## SUBDIVISION REPORT - CONCEPT

► FILE #: 11-SF-20-C AGENDA ITEM #: 34

SUBDIVISION: CLEAR SPRINGS PLANTATION

► PROPOSED USE: Removal of requirement to to install sidewalks, condition #9 of

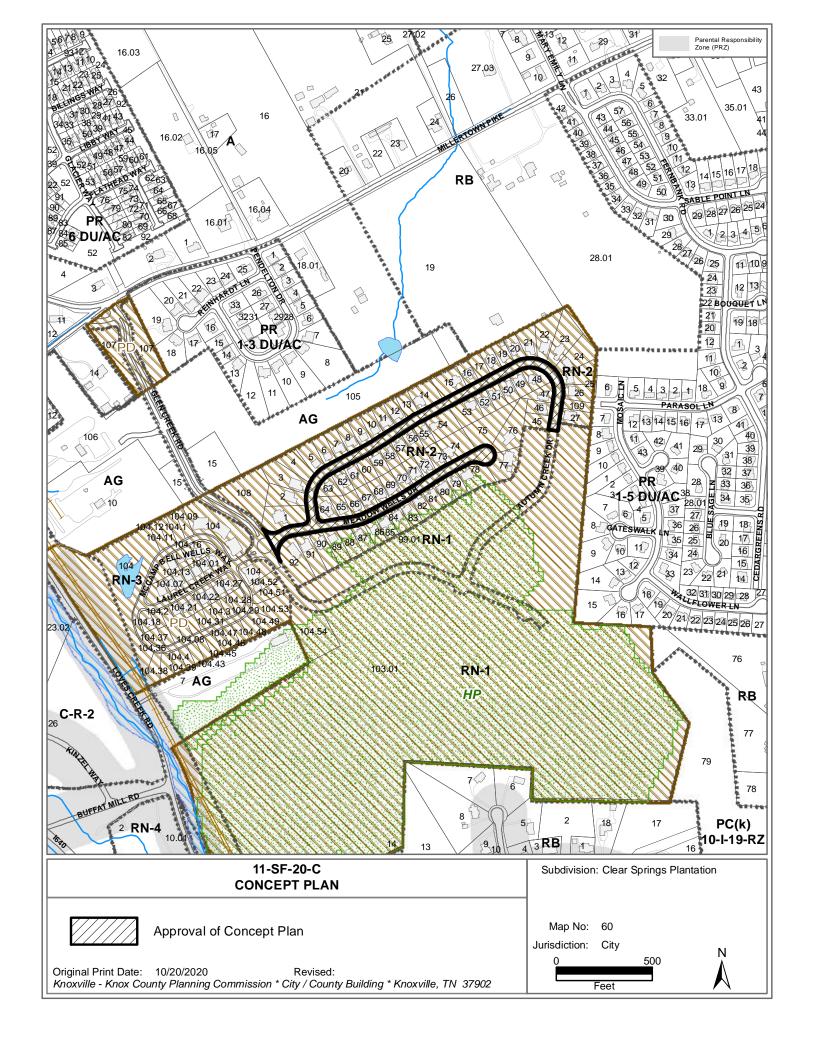
The applicant is requesting that the Planning Commission remove the sidewalk condition from the concept plan approval for Clear Spring Plantation Subdivision (4-SL-05-C / 4-N-05-UR) that was approved by the Planning Commission on April 14, 2005, and to approve a variance to the entry road that has already been constructed but had previously not been verified to meet the required public road standards. The subdivision was originally approved while it was in Knox County and the City of Knoxville annexed the subdivision in 2006.

The approved sidewalk condition reads as follows: "9. Sidewalks are to be constructed on one side of all streets. Sidewalks will be a minimum of 4' wide with a 2' planting strip between the back of curb and the sidewalk. All sidewalk construction must comply with the requirements of the Americans With Disabilities Act." The applicant is requesting the sidewalk requirement to be removed from two existing roads only, all of Meadow Wells Drive and the portion of Autumn Creek Drive shown on the plan.

APPROVE the applicant's request to remove the sidewalk condition (condition #9) of the Concept Plan approval of April 14, 2005, subject to 1 condition.

1. The sidewalk on Glen Creek Road must be extended through the traffic circle to make a continuous sidewalk along this entire road.

ASB4

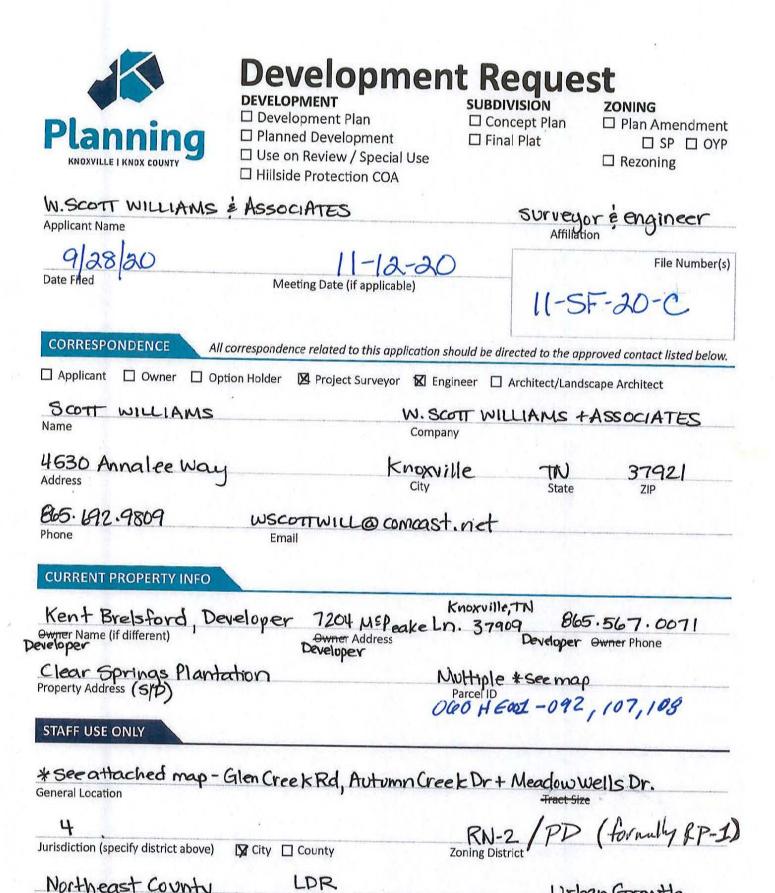
1) Reduce the vertical curve length from 232.5 feet to 150 feet at PVI

station 11+67.48 on Glen Creek Drive.

1. Vertical curb length from 232.5ft to 150ft. @ PBI Station 11 + 67.48 on Gle Justify variance by indicating hardship: due to stream protection and Street lights have been provided			
2. Remove requirement for sidewalk@Meadow wells Dr + Autumn Creek Dr Justify variance by indicating hardship: Topography of existing driveways			
3.			
Justify variance by indicating hardship:			
4.			
Justify variance by indicating hardship:			
5 Justify variance by indicating hardship:			
Justify variance by indicating hardship:			
7			
Justify variance by indicating hardship:			
I certify that any and all variances needed to meet regulations are requested above, or are attached. I understand and agree that no additional variances can be acted upon by the legislative body upon appeal and none will be requested. I hereby waive the requirement for approval or disapproval of the	Miller

▶ APPROVE variance 1 based on the recommendation from City of Knoxville Department of Engineering and because the site conditions restrict compliance with the Subdivision Regulations and the proposed variances and alternative design standards will not create a traffic hazard.
